Re: **LETTER OF TRANSMITTAL  
ROOMS TO GO STORE EXPANSION AND REMODEL  
18722 South Dixie Highway  
Cutler Bay, FL 33157  
POST BID ADDENDUM #5**

## **POST BID ADDENDUM NO. FIVE**

Incorporate the following revised CASCO drawings dated 01/29/2024, with revisions including, but not necessarily limited to, those listed below:

3 WALL SECTION  
A6.3 SCALE: 3/4" = 1'-0"

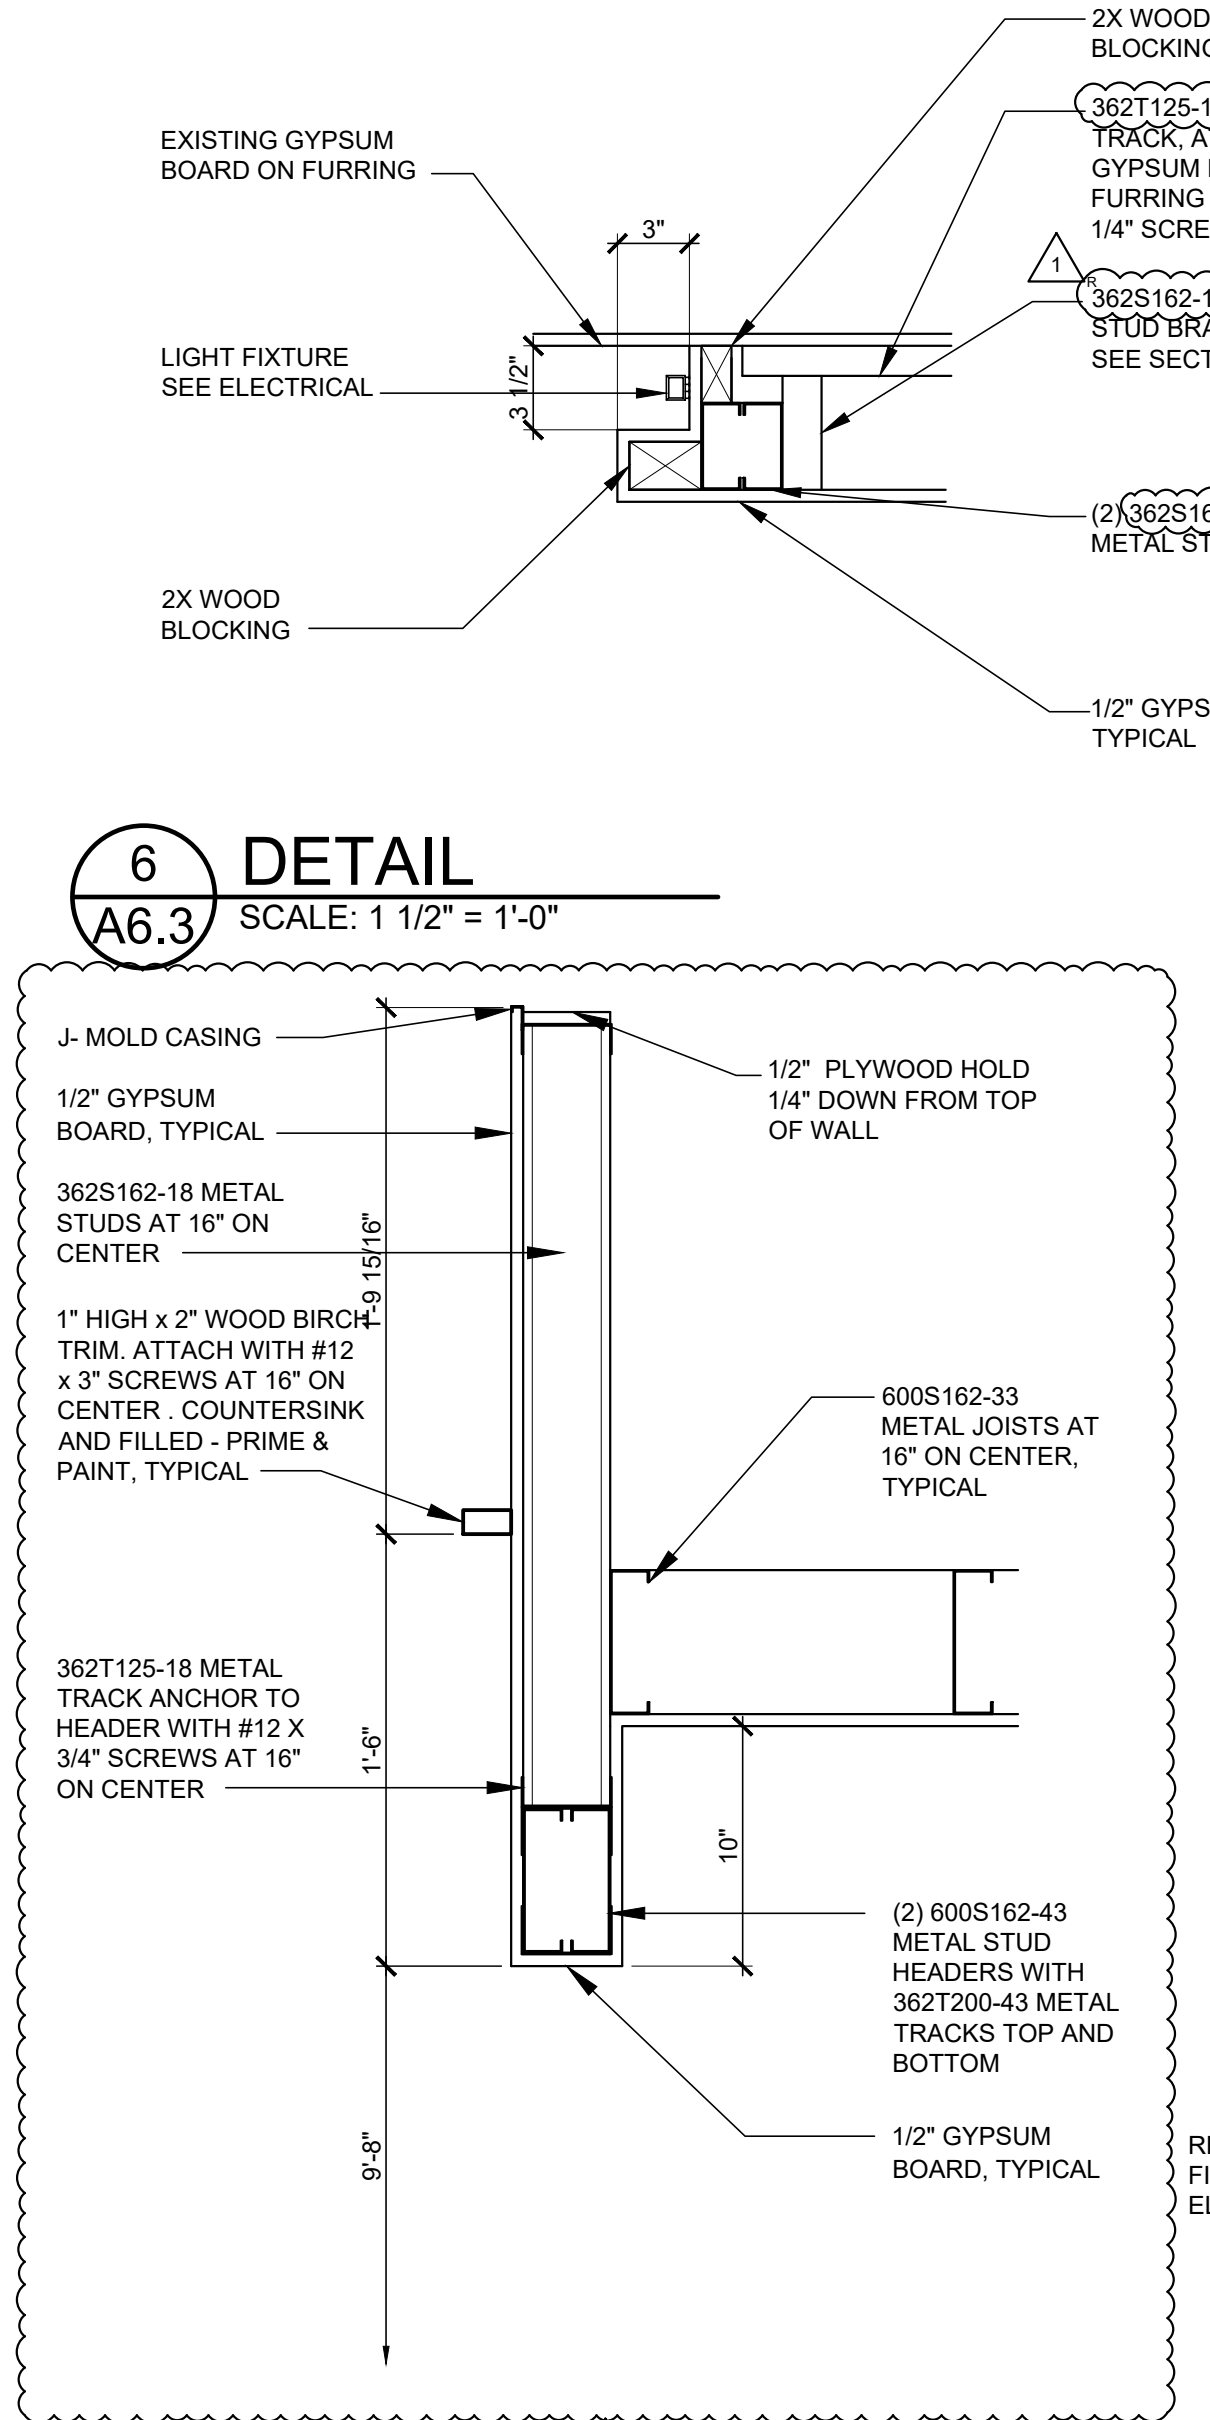
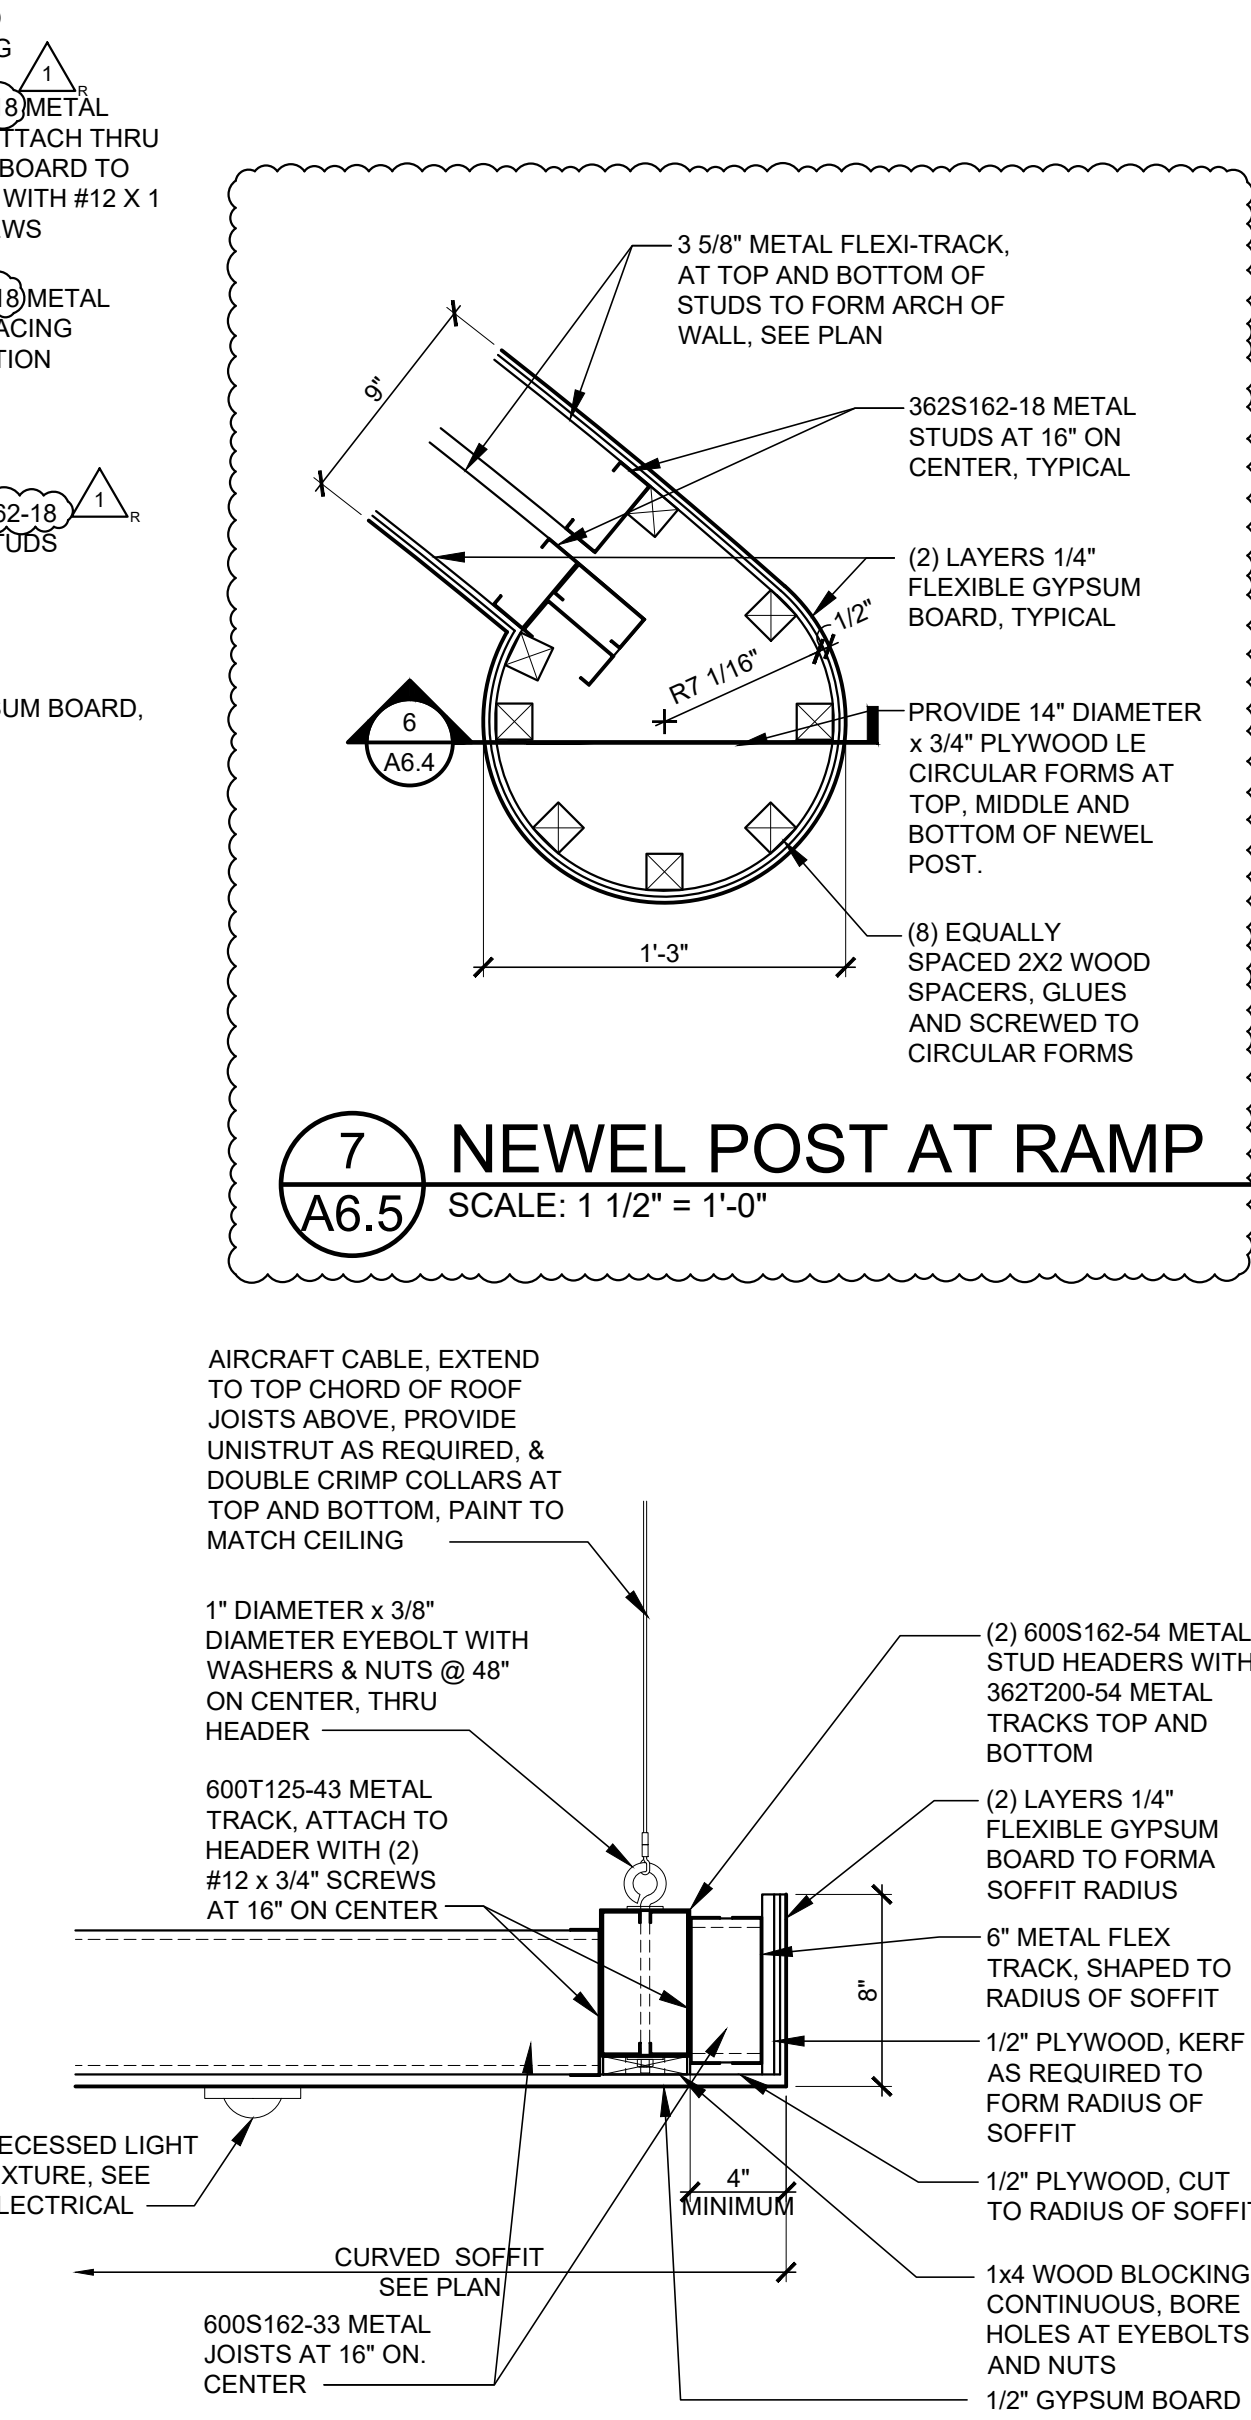
18. Sheet A6.3 – Revision No. 1: Revised Elevations “R2”, “T”, “U”, “V”. Revised Detail 4/A6.3. Revised 362S162-33 metal studs to 362S163-18 metal studs. Added Detail #7/A6.3.

**1 POWER PLAN**  
E2.0 SCALE: 1/8" = 1'-0"

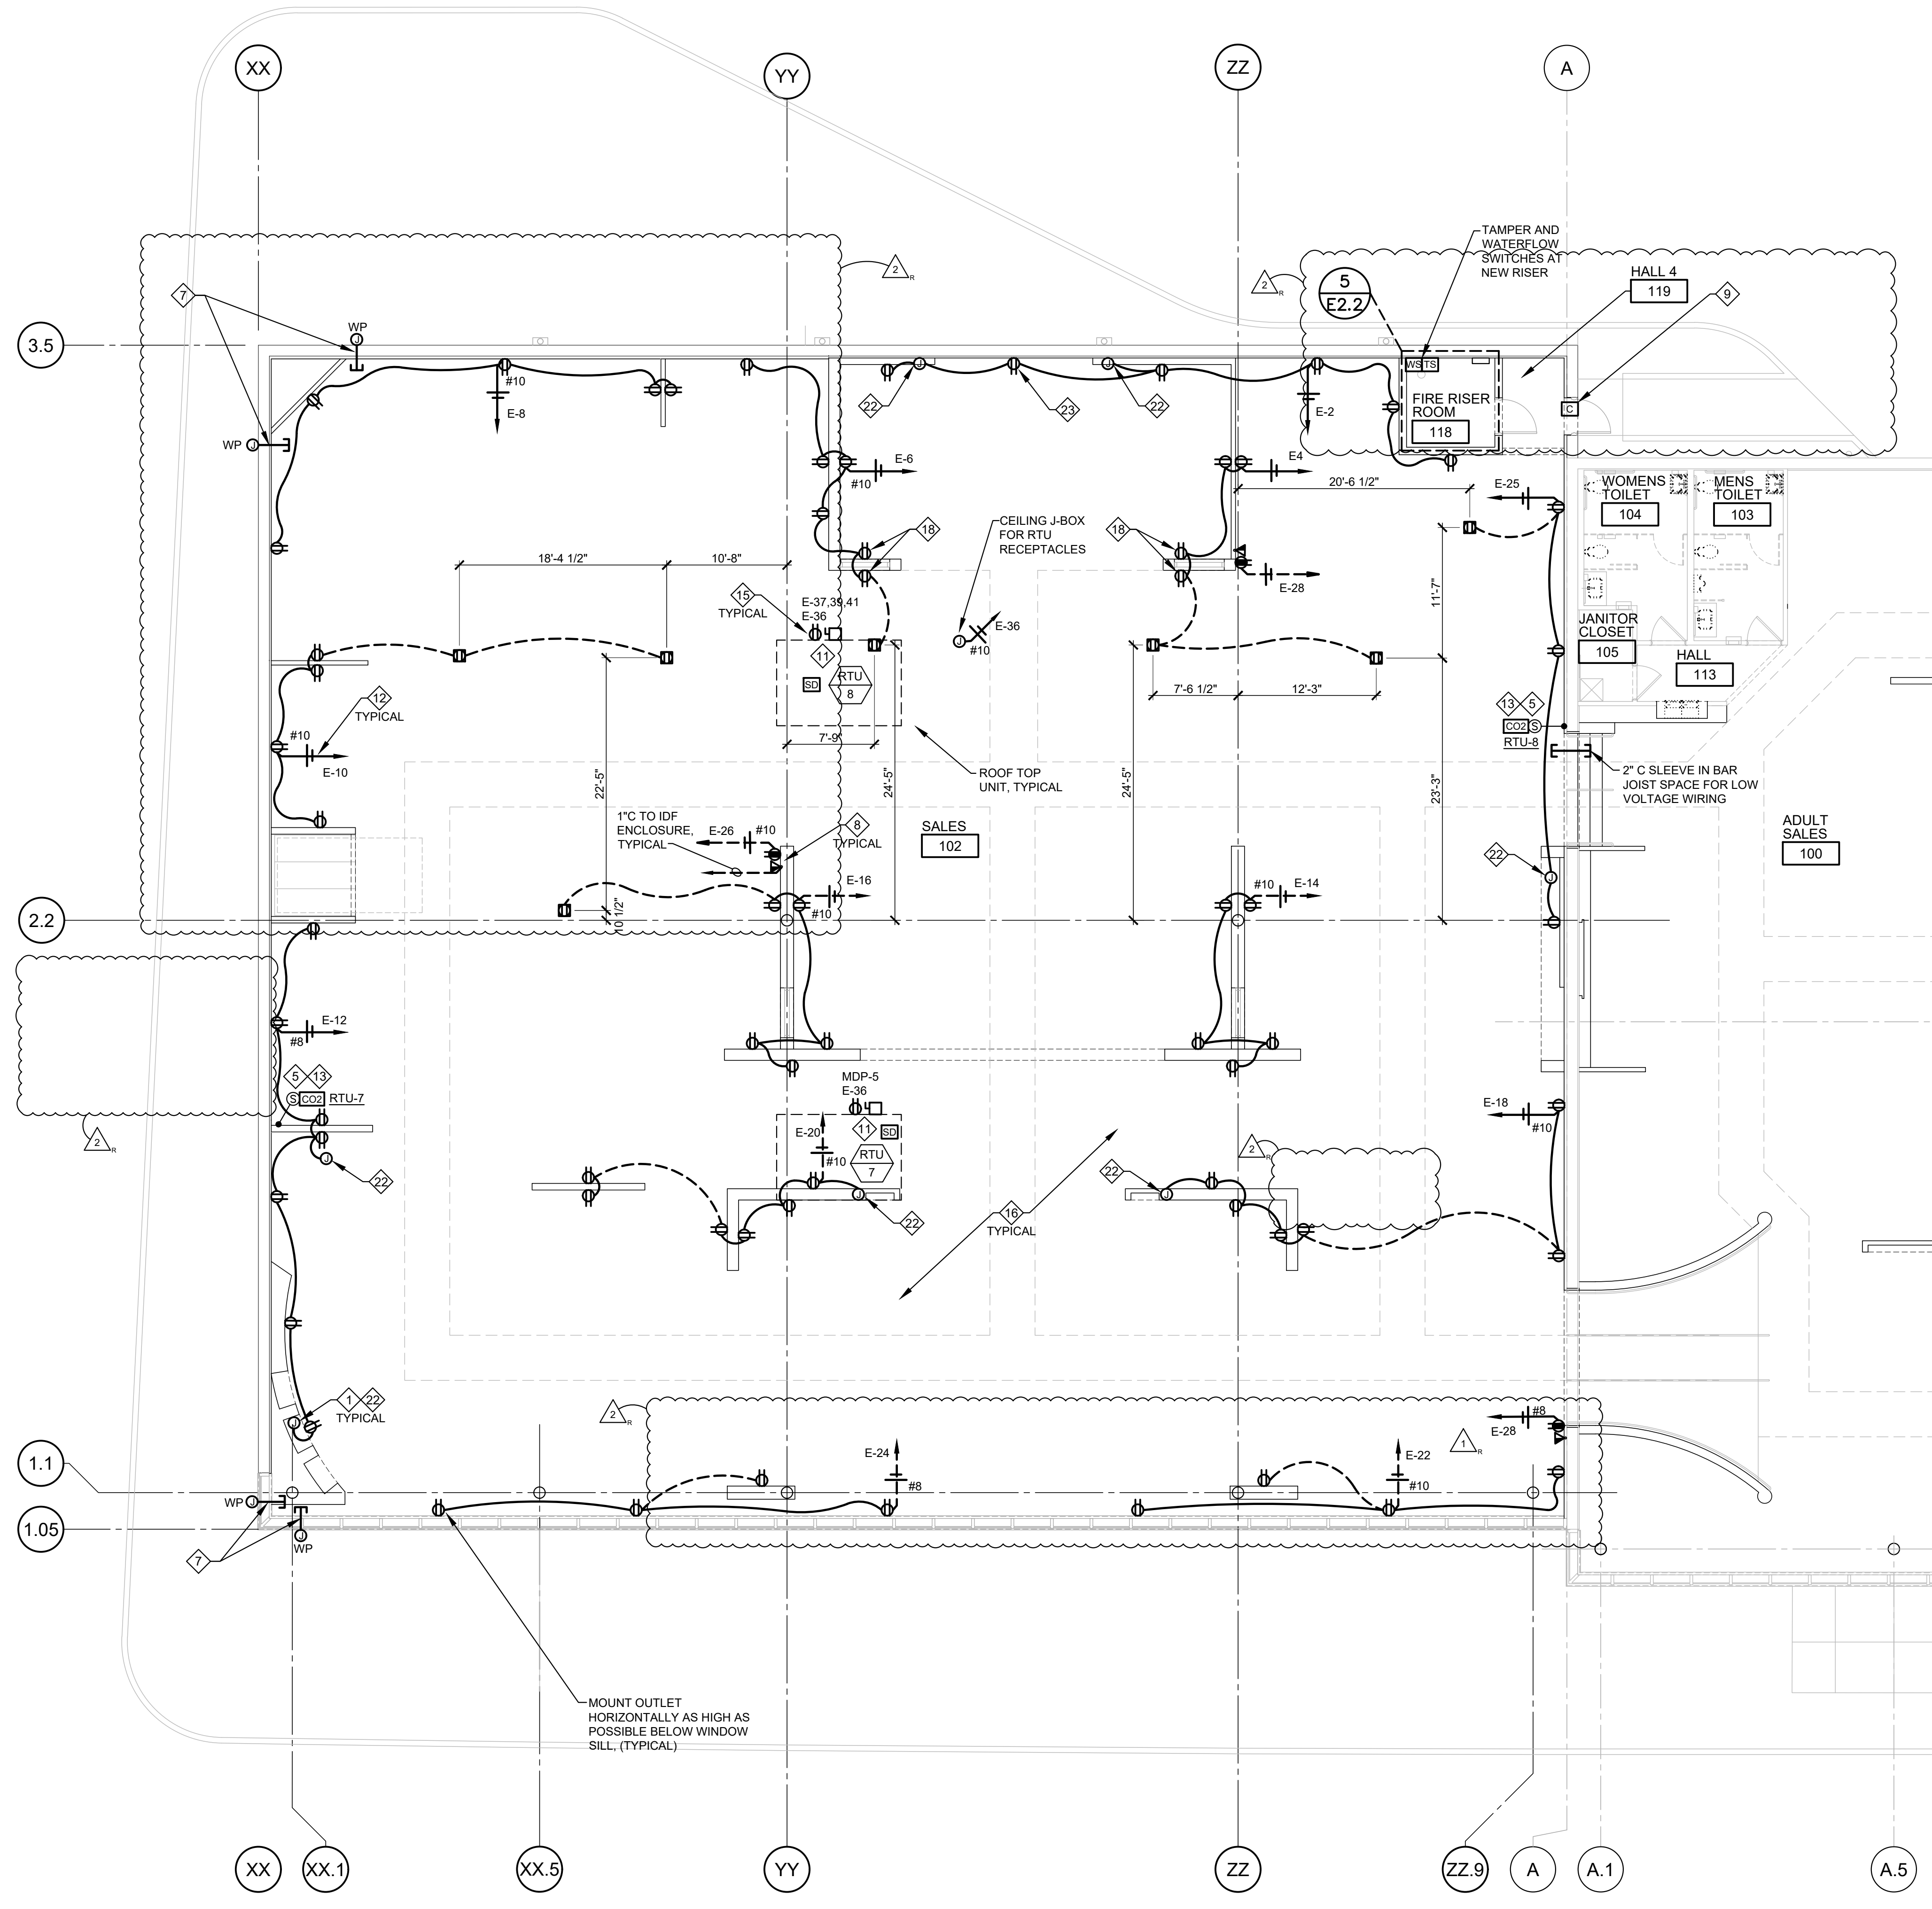
35. Sheet E2.0 – Revision No. 2: Revised floor plan and power plan in Sales #102. Removed bedding gallery and revised partition layout. Revised receptacle locations. Removed receptacle in Hall #119. Removed ten receptacles in Sales #102 and one computer station. Relocated computer station. Removed graphic displays and receptacles. Removed side door and door security contact. Added detail callout for enlarged Risers room plan. Revised general note #A to clarify existing fire alarm panel to be replaced. Removed keynote #21.
